Service Manual

SA-AK330P / SA-AK330PC

Top Cabinet change (Additional Information)
Please file and use this supplement manual together with the service manual for Model No. [SA-AK330P/PC-K/S, Order No. MD0410497C1].

2.1. Cabinet Parts Location (Additional Information)

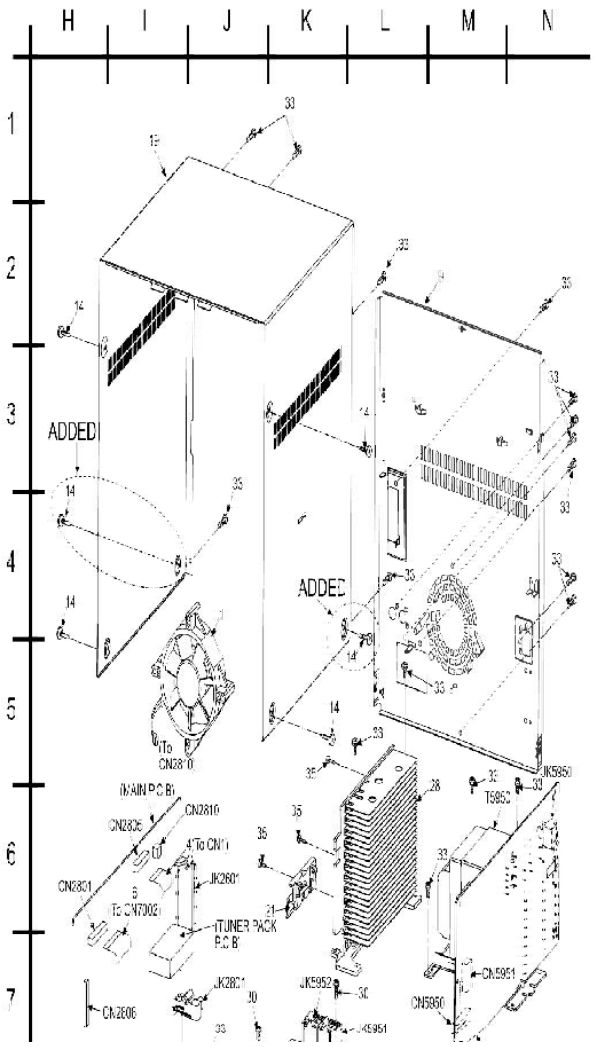
During the replacement of the top cabinet for the mentioned models, the below rules of compatibility (Table 1) must be followed & parts must be replaced correctly. This is mainly due to top cabinet specification change (additional of one screw hole) for improvements.

- When replacing the new top cabinet, ensure that the NEW bottom chassis must also be changed together at the same time (Refer to Table 1).

With reference to page 94 (section 23.3.1) of the original service manual for SA-AK330P/PC-K/S. The cabinet parts location below is for the new implementation.

Ref. No.	Part No.	Part Name & Description	Remarks
		CABINET AND CHASSIS	
19	RKMX0105-K1	TOP CABINET	[M] PC-K,P-K
19	RKMX0105-S1	TOP CABINET	[M] P-S
22	RMKX0099-2	BOTTOM CHASSIS	[M]
